PRODUCT CHANGE NOTIFICATION

Reference: **EP_1506442**

D relay series

Latching relay, 2PDT / 1A

LIE Part Number:

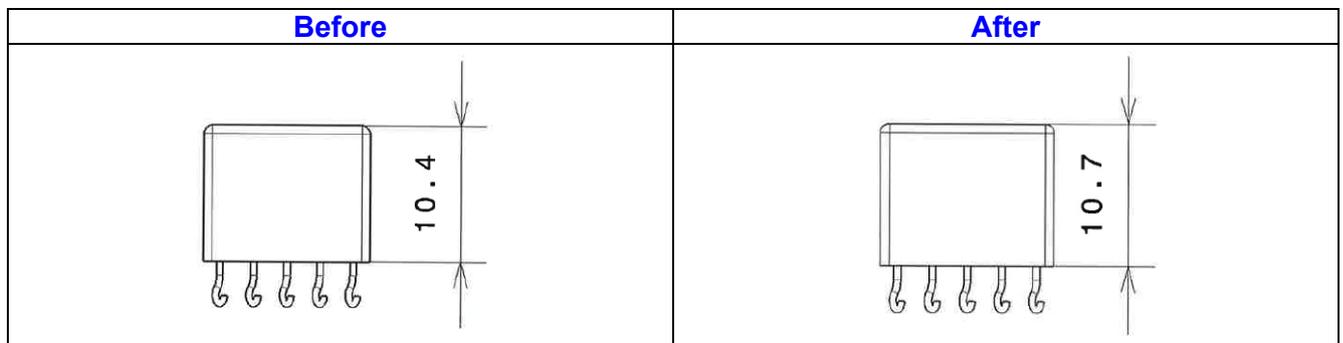
Modification of the total height of the relay with the replacement of the can (050B0001) by the raised can (050B0002). This evolution is effective for all types of can for D relays series.

For space application, the ESCC 3602/019 issue 9 validate the external dimension of the D relay of 10.7 mm maximum.
